Product Change Notification / KSRA-09NSTT965

CCB 4251 Final Notice: Qualification of MTAI as an additional final test site for selected Atmel ATF16V8Bxx device family available in 20L PDIP package.

CCB 4251 PRE AND POST CHANGE SUMMARY

TUBE

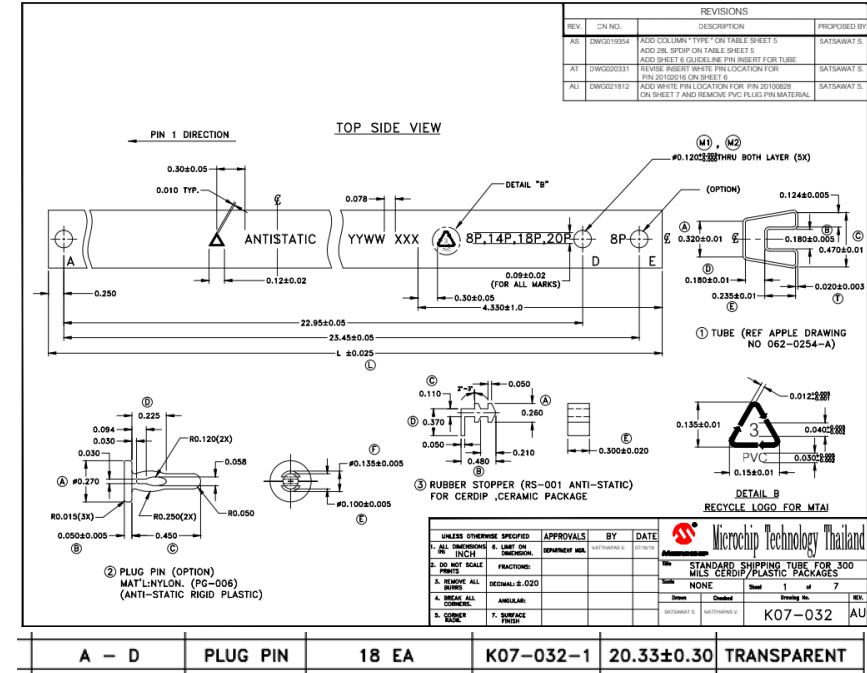
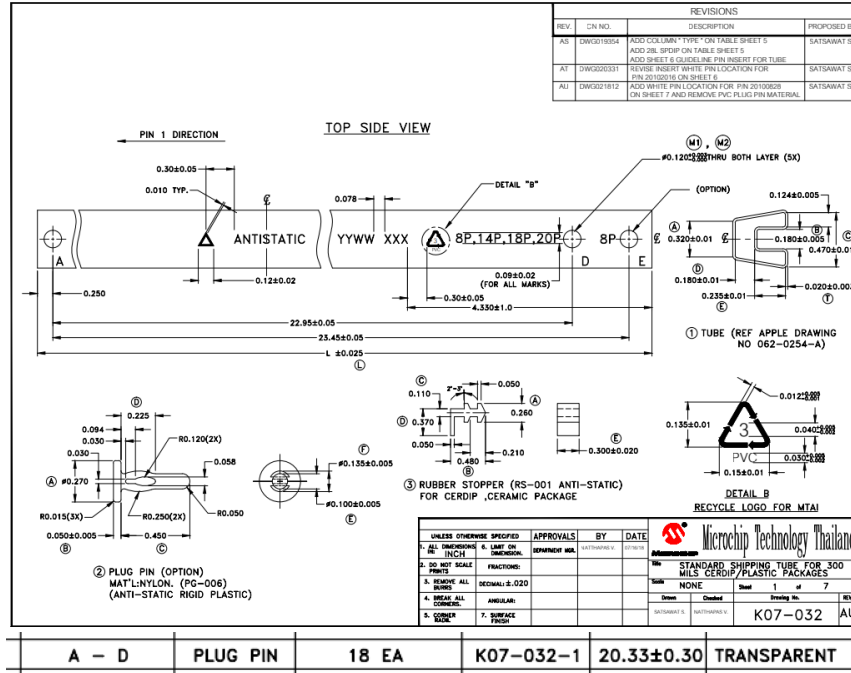
Plant	Dimension A	Dimension B	Dimension C	Length	Thickness	Color
MPHL	0.180+/-0.01in	0.320+/-0.01in	0.235+/-0.01in	20.33 in	0.020+/-0.003in	Transparent
MTAI	0.180+/-0.01in	0.320+/-0.01in	0.235+/-0.01in	20.33 in	0.020+/-0.003in	Transparent

TUBE Packing method for Package

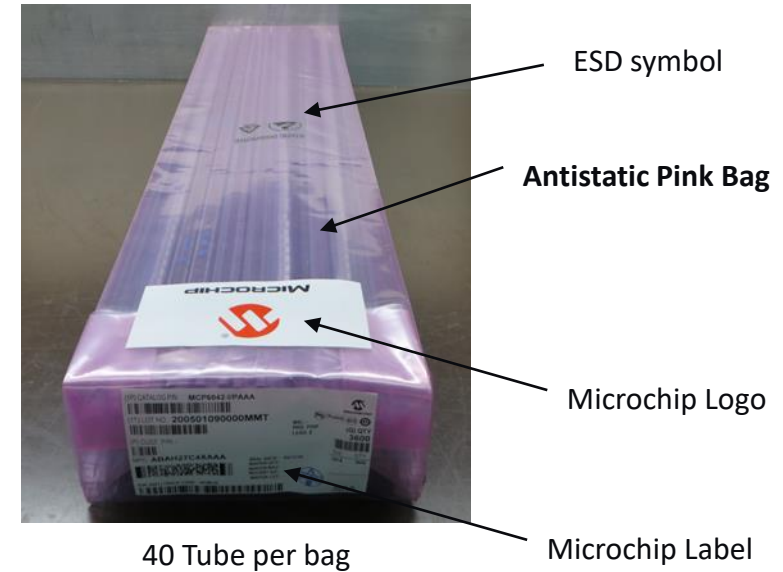
Carton	Dimension W x L x H (cm)	Number of Bag/carton
M01-020 (PD)	15x71.5x5	1
M01-021 (PI)	17x65x8	1
M01-022 (PP)	15.5x62x14	2
M01-023 (PT)	22.5x63x16.5	3
M01-024 (P4)	32x63x15.5	4
M01-034 (P5)	36x63x16.5	5
